Planning & Zoning Board Meeting

ZONING MEMORANDUM

Meritage Homes- Elevation/ Architectural Plans Hillside Groves (The Reserve PUD) Applicant: Meritage Homes

Meritage Homes 4R20 (Formerly Hibiscus)

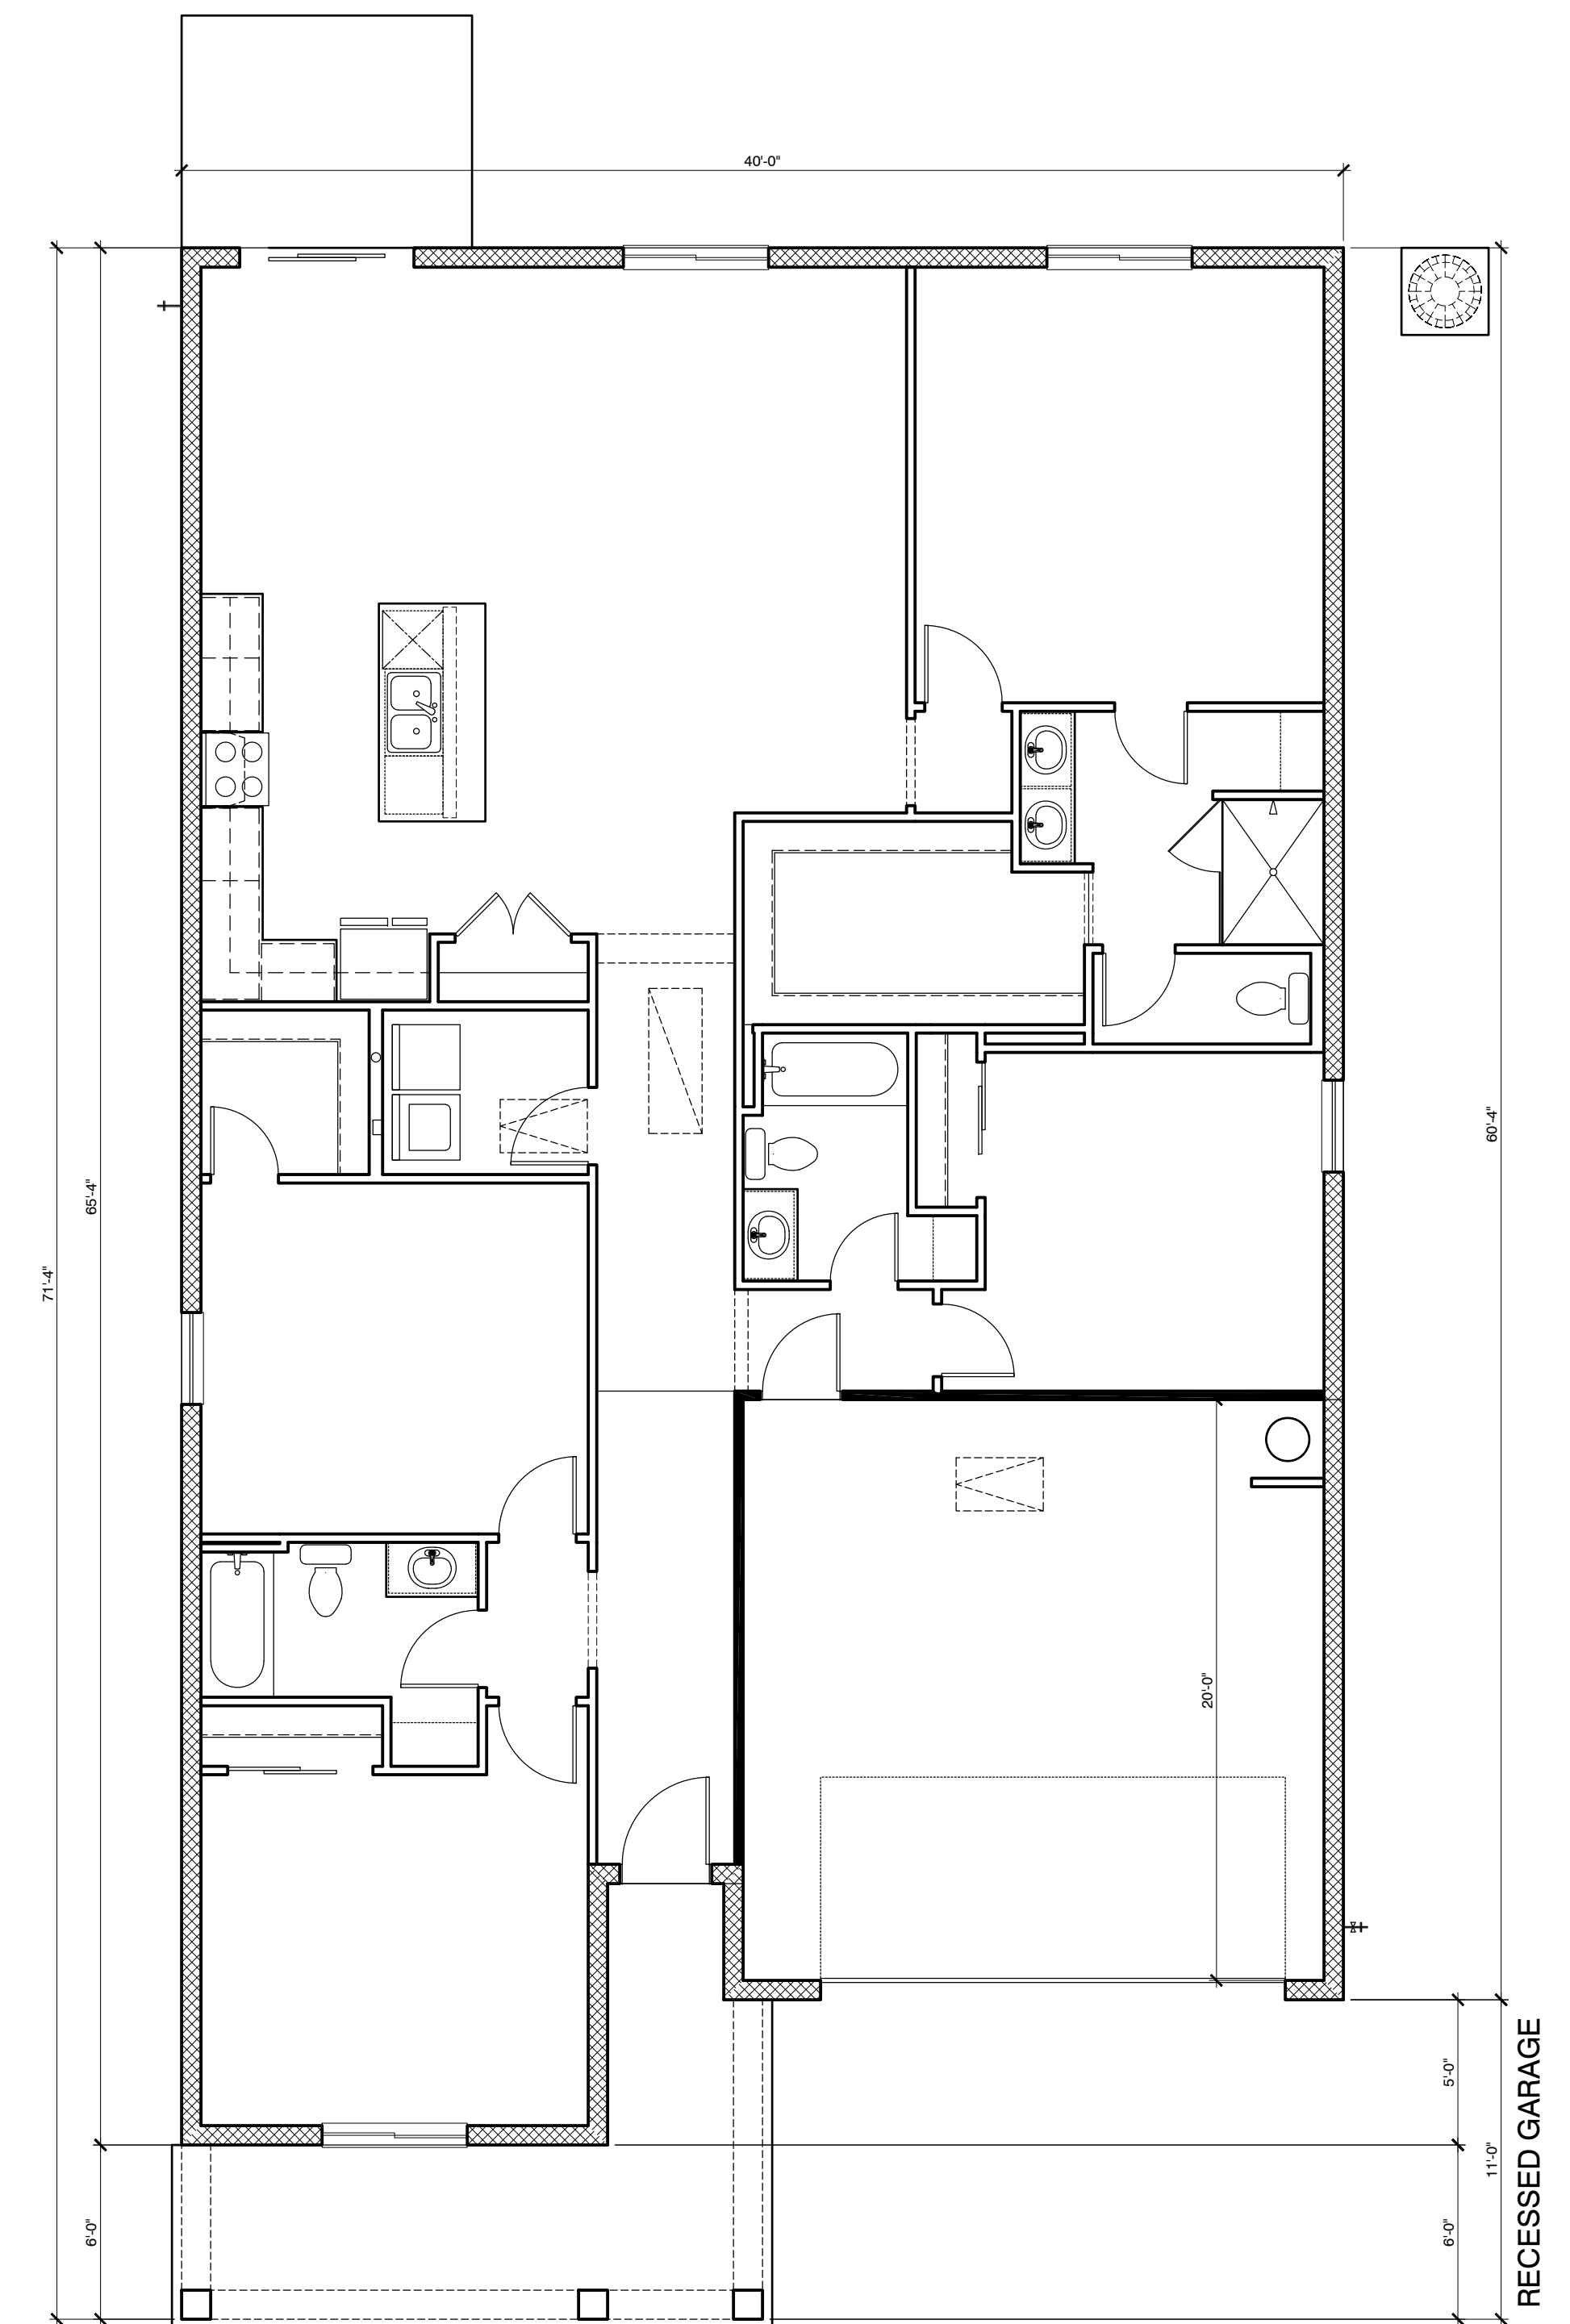
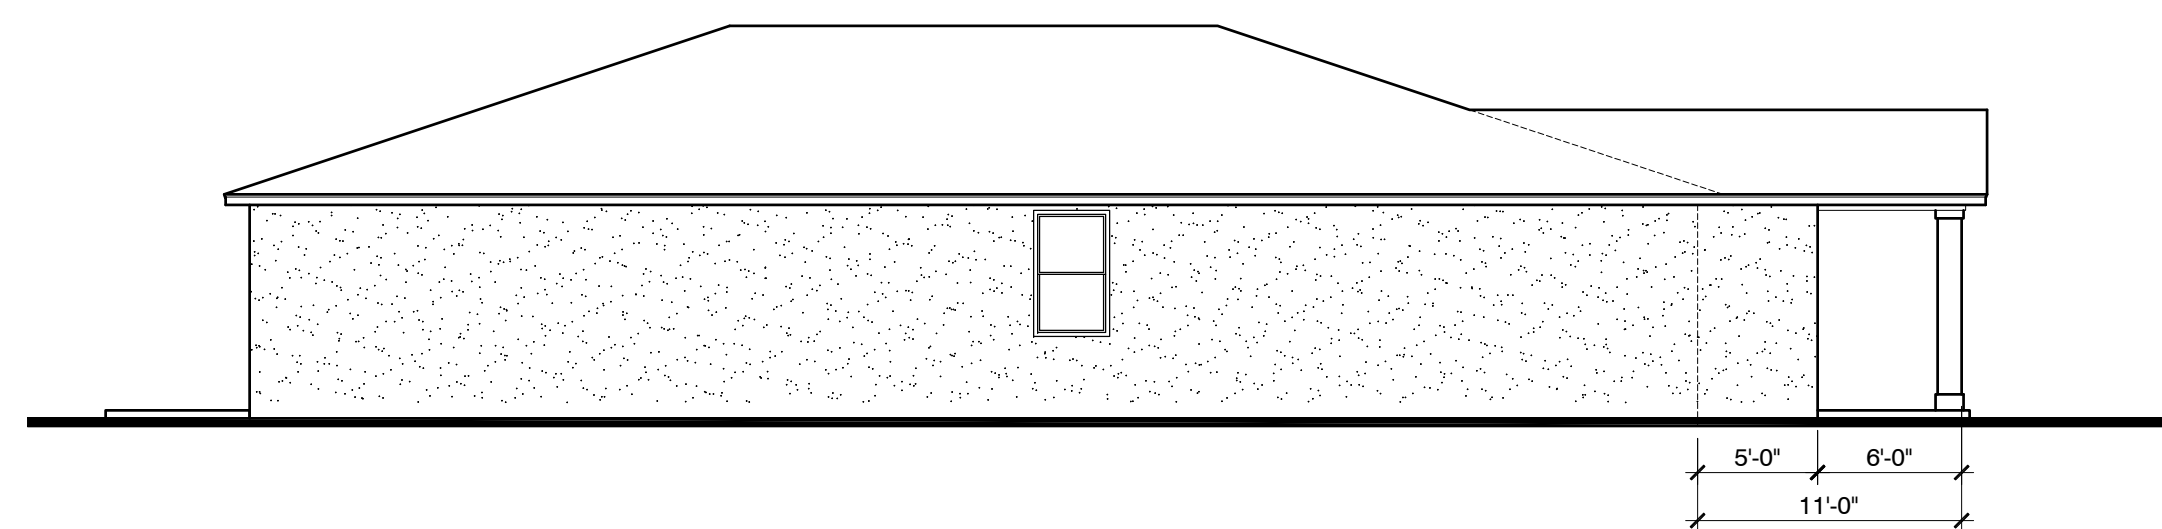
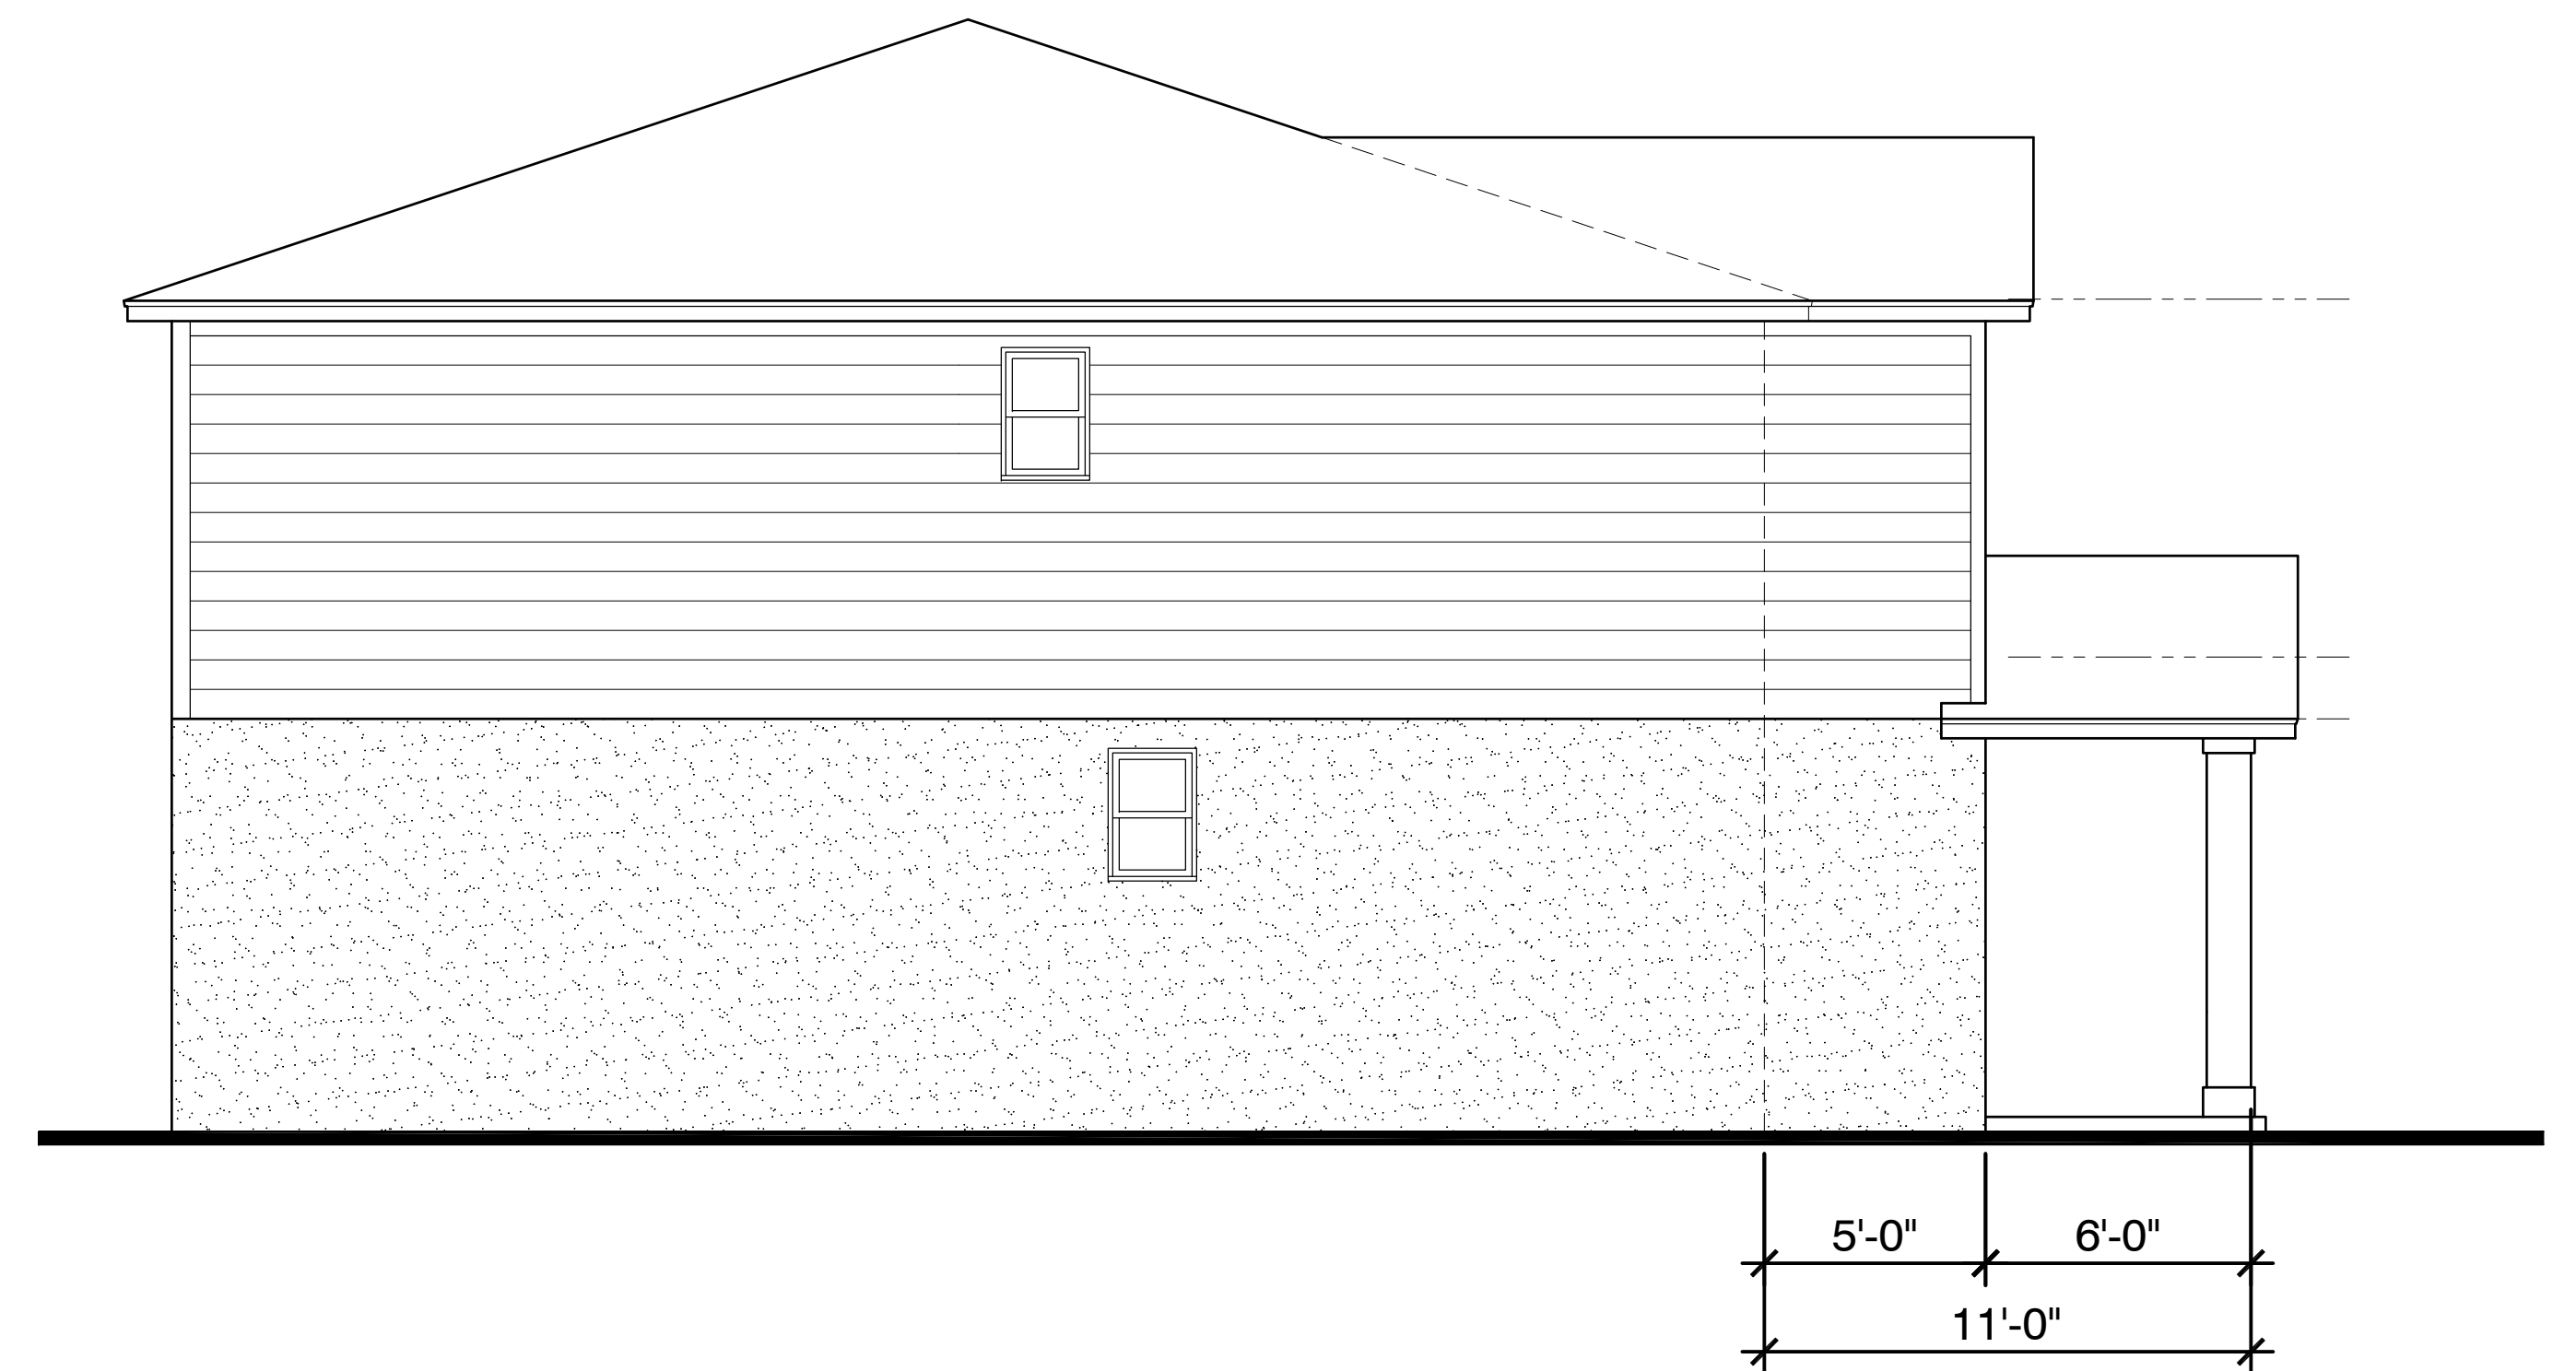
The proposed models appear to provide porches and recessed garages consistent with LDC Sec. 4.06.02 (A) (2) and (3). Additional detail on the porches would be helpful though to determine if they are at or above grade or have articulation designating them as usable front porches. As an example, none of the porches show railings as part of the design.

The proposed elevations show what appears to be stonework and varying materials on the models, however no product types, colors or materials are identified on the plans. The elevation plans need to be revised to demonstrate and specify materials to ensure that they are consistent with the following LDC Sections which state:

The proposed elevations do not identify the roof materials to be used nor detail on eave design. The plans need to be revised to demonstrate and specify roof materials and eaves detail to ensure that they are consistent with the following LDC Sections:

The application provides some of these details but not all that are required for each of the facades. Consistent with LDC Sec. 4.06.03, the plans need to be revised to show and label the front, side, and rear facade elevations for each model and identify the specific architectural details on each façade, demonstrating how they are consistent with the type and quantity required in LDC Sec. 4.06.03 (C).

Recommendation: The model elevations should be revised consistent with the requirements identified in the review comments below and be brought back to the Planning and Zoning Board for consideration.
